Examination into Lewes District Local Plan Part 2 Site Allocations and Development Management Policies – Inspector's Matters, Issues, and Questions Discussion Note

Please find below our responses to the Inspector's Matters, Issues, and Questions Discussion Note on behalf of Plumpton Action Group. The Action Group's interest relates to Policy GT01.

Technical Note

Proposed Gypsy & Traveller Site, Plumpton MARCH 2019

INDICATIVE SOUTHERN ACCESS LOCATION AND VISIBILITY PLANS

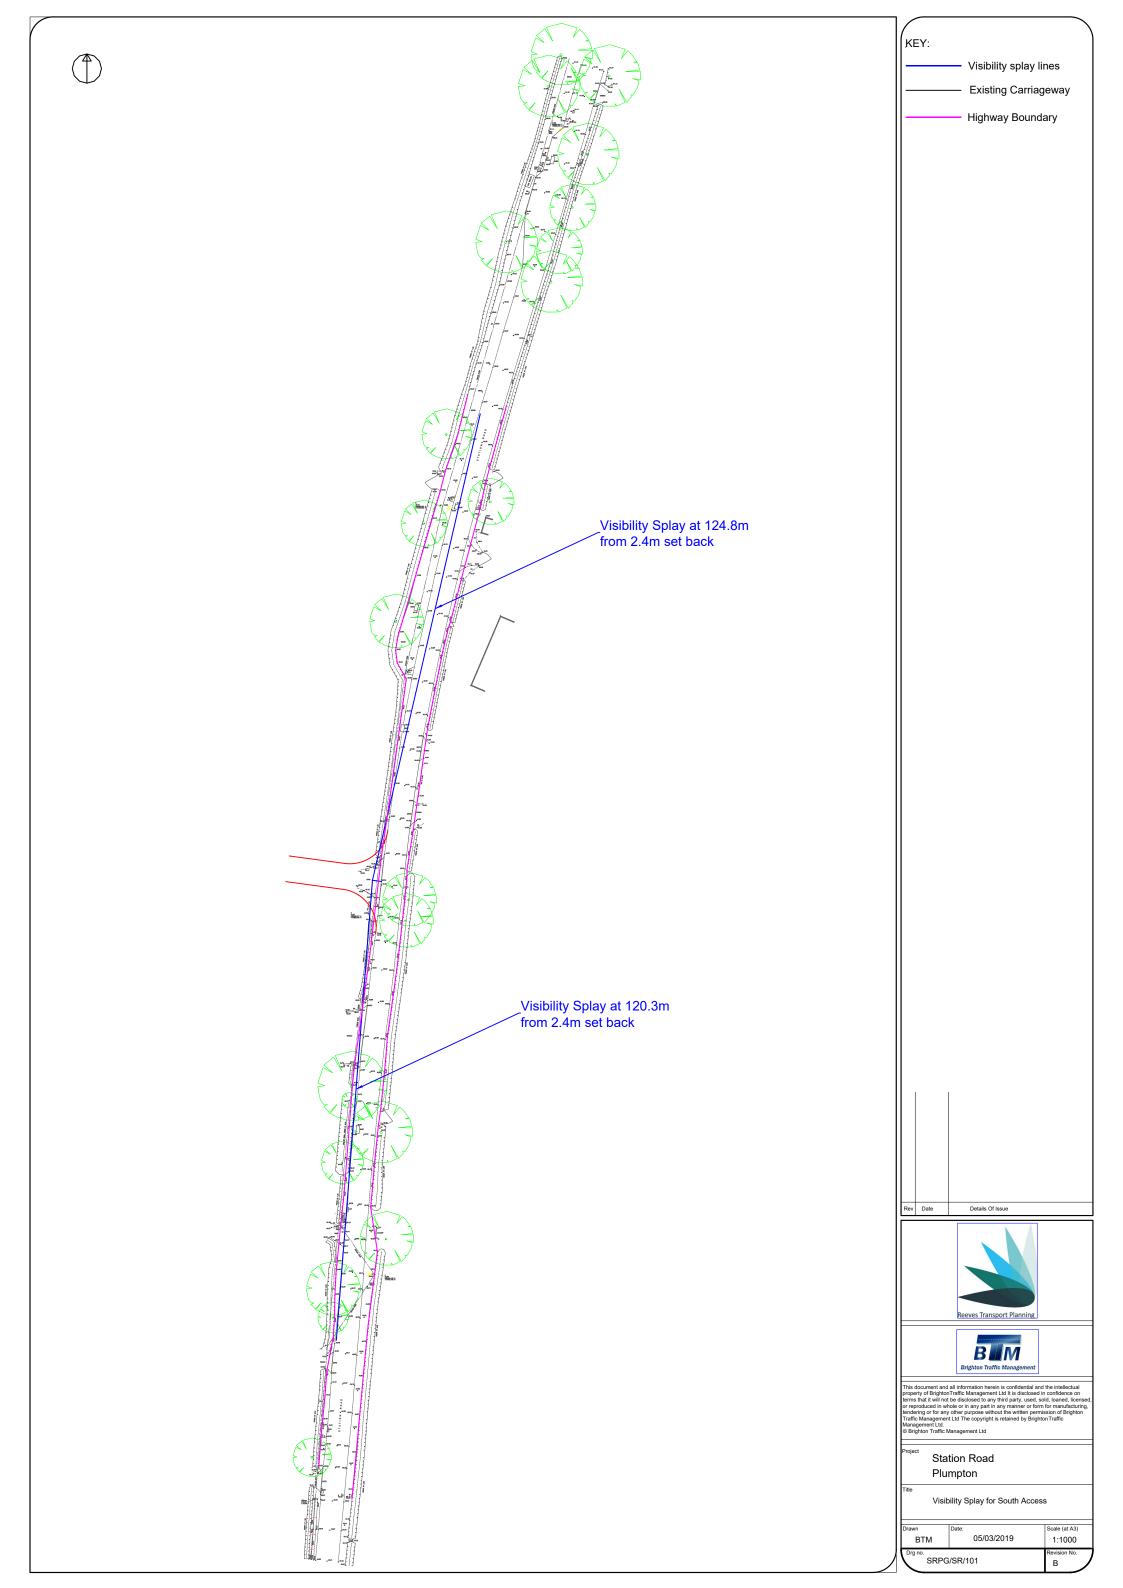
- 2.7 Appendix 3 contains a plan of the southern access with the required visibility splays. The plan demonstrates that the southern visibility splay crosses third party land to the south of the access. Appendix 4 has an extract of Appendix 3 that highlights the third party land, which will be required to form the required visibility splay. The extract includes the area, hatched with green shading, that is outside the land identified in Policy GT01.

- 3.3 Plans attached at Appendix 3 and Appendix 5 demonstrate that it is not possible to secure the visibility splays for the southern access option, as part of the south splay is over third party land. The plans also illustrate that the northern access requires the removal of circa 22metres of hedgerow. The gradient of the northern splay, of the southern access, is 4.8% and of the northern access is 4.2%.

- 3.8 The southern access location shown at Appendix 3 is not deliverable because the visibility splays required would cross third party land or exceed maximum acceptable gradients. The north access location shown at Appendix 5 is not deliverable because the visibility spays are over a section of Station Road that exceeds maximum gradients. The nature of the traffic and excessive gradients would result in an increased risk of accidents. This contracts guidance in the DMRB. In addition, the delivery of the southern visibility splay would result in over 22 metres of hedgerow being removed.

INDICATIVE NORTHERN ACCESS LOCATION AND VISIBILITY PLANS

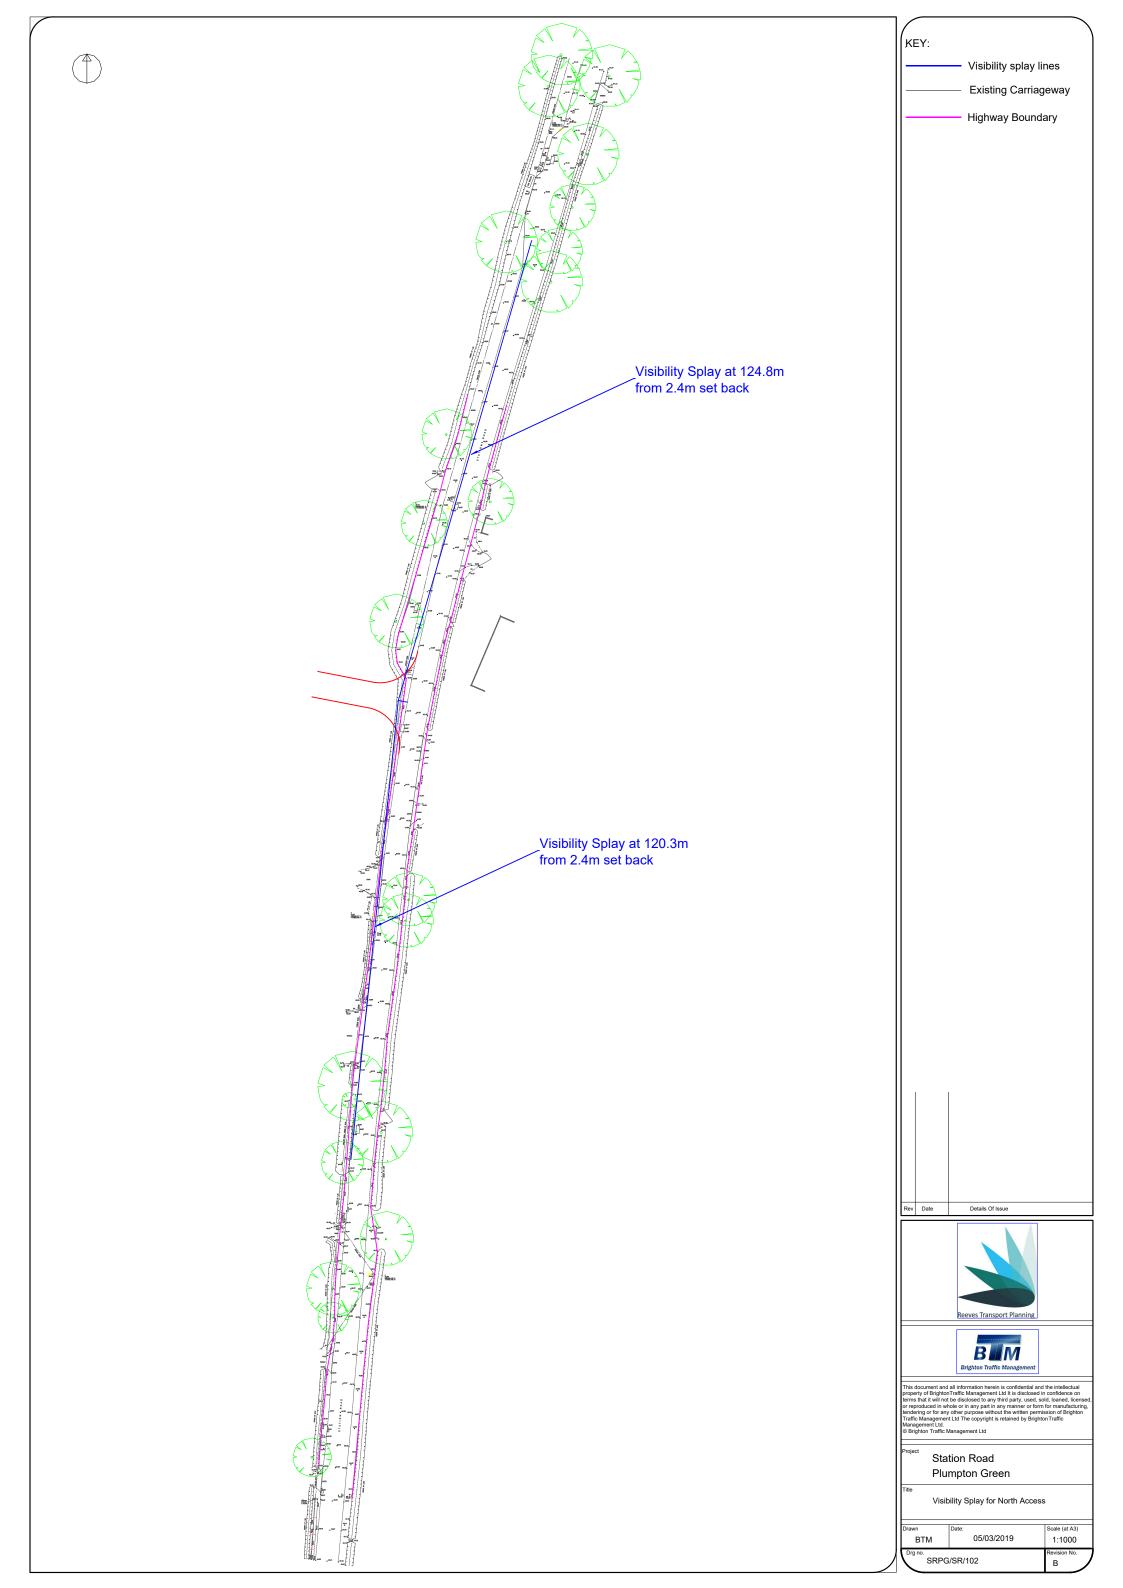
- 2.9 The plan of the northern access is attached at Appendix 5. The plan illustrates that the southern visibility splay can be secured, over land identified in Policy GT01, provided a section of, at least, 22metres of hedgerow is removed. The stepped in section of the adopted highway, just to the north of the possible access location, means that the visibility splay to the north can be appropriately secured.
- 2.10 The relevant spot levels and gradients of the Station Road sections incorporating the visibility splays, are set out below.
